NOTICE OF A TYPE II DECISION ON A PROPOSAL IN YOUR NEIGHBORHOOD

CASE FILE NUMBER: LU 17-279980 HR – EXTERIOR ALTERATIONS TO BUILDING AND SITE

Site Address: **2216 NE 15th Avenue**

PROPOSED North and East
 ELEVATIONS
 Site Address:
 2216 NE 15th Ave.
 Portland, Or 97212

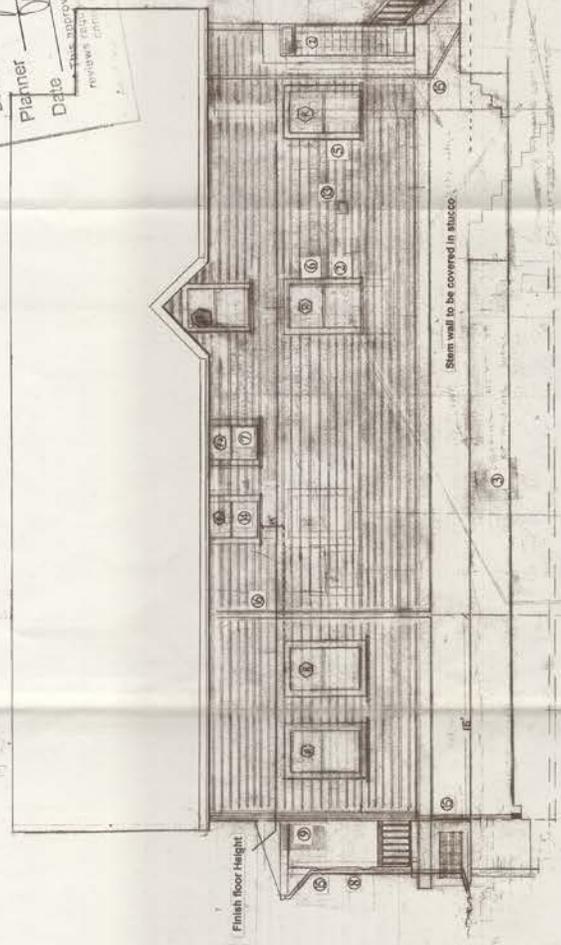
- Existing window to remain in wall.
 - French door window added as per comments made in BDC Memorandum #4 (7/6/15)
 - Dimensions changes to match 'R' window as per comments made in 7.

- 'F-2' window added as per Memorandum 34 (6/3/15)
 - Columns changed from square to 'lumed' as per comments from ICA (7/6/15). See figure A2 on sheet A4.

- Newest porch as per ICA comments (7/6/15)
 - French doors centered in porch as per comments made in Memorandum #3 (7/6/15)
 - Kitchen windows centered on north half of east as per comments made 13.

- Exhaust for gas fireplace
 - Window F moved from 1st floor to second floor; see 'Existing North Elevation' on A2
 - Dimensions show as per comments from ICA (7/6/15)
